Access Compliance Report

Public Rights-of-Way

(Curb Ramps)

Intersection ID: 10020719	Main Street: BEATTIES_FORD_RD	Cross Street: N/A	Location: W
ADA ID: 76170E17A0BE	Ramp Type: Perp	Initial Pass/Fail: Fail	Overall Compliance: No
Codes/Mitigation Info/Possible Solution		Field Measurements/Component Compliance	
Severity Score: 12.5

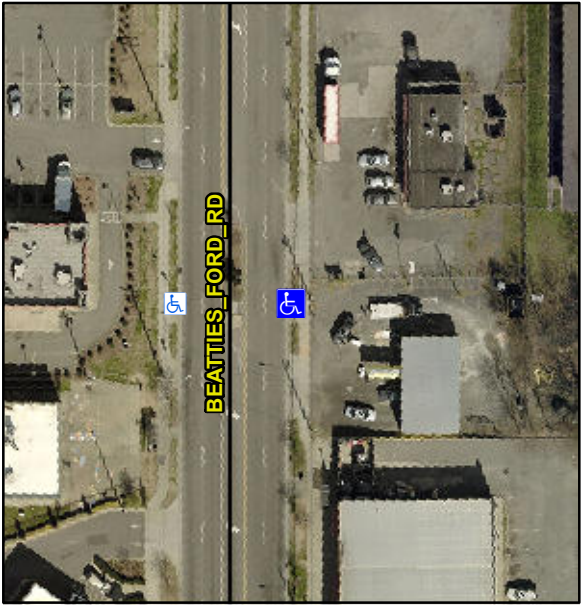
Possible Solutions:	Compliance	Description	Data	Compliance	Description	Data
	Remove & Replace Entire Ramp.	N/A	Ramp Length (in)	48.0	No	Ramp Slope (%)	10.8
		Yes	Ramp Width (in)	48.0	Yes	Ramp XSlope (%)	1.3
		N/A	Flare Type LT	N/A	N/A	Flare Type RT	N/A
		N/A	Flare Slope LT (%)	N/A	N/A	Flare Slope RT (%)	N/A
		N/A	Flare Traversable LT?	N/A	N/A	Flare Traversable RT?	N/A
		N/A	Landing Length (in)	N/A	N/A	DWS Provided?	N/A
		N/A	Landing Width (in)	N/A	N/A	DWS Contrast?	N/A
		N/A	Landing Slope (%)	N/A	N/A	DWS Length (in)	N/A
		N/A	Landing X Slope (%)	N/A	N/A	DWS Full Width?	N/A
Surveyor Notes: N/A PROW/ADA: R304.2.2		N/A	Landing Curb? (Y/N)	N/A	N/A	DWS Offset (in)	N/A
		N/A	Shared Landing?	N/A			
		N/A	Gutter Ponding?	N/A	N/A	Gutter Slope (%)	N/A
		N/A	Gutter Lip Ht (in)	N/A	N/A	Gutter X Slope (%)	N/A
		N/A	Painted X Walk1?	No	N/A	Painted X Walk2?	N/A
			X Walk 1 Direction	To E		X Walk 2 Direction	N/A
		N/A	X Walk 1 Width (in)	N/A	N/A	X Walk 2 Width (in)	N/A

X Walk 1 Slope (%)	4.5		X Walk 2 Slope (%)	N/A
			X Walk 1 X Slope (%)	0.3		X Walk 2 X Slope (%)	N/A
		N/A	Ramp inside XWalk1?	N/A	N/A	Ramp inside XWalk2?	N/A
Street 1 Name Stop Condition-Street 2 Street 2 Name Stop Condition-Street 1			Road Slope (%)	N/A	N/A	Clear Space?	N/A
			Road X Slope (%)	N/A	N/A	Clear Space to XWalk (in)	N/A
		N/A	Any Obstructions?	N/A	N/A	Storm Grate/Utility Hazard?	N/A
			Obstruction Type			Storm Grate/Utility Type	
					N/A		N/A
					Yes	Surface Condition? (G/P)	Good
Total Cost:		\$	1850.00
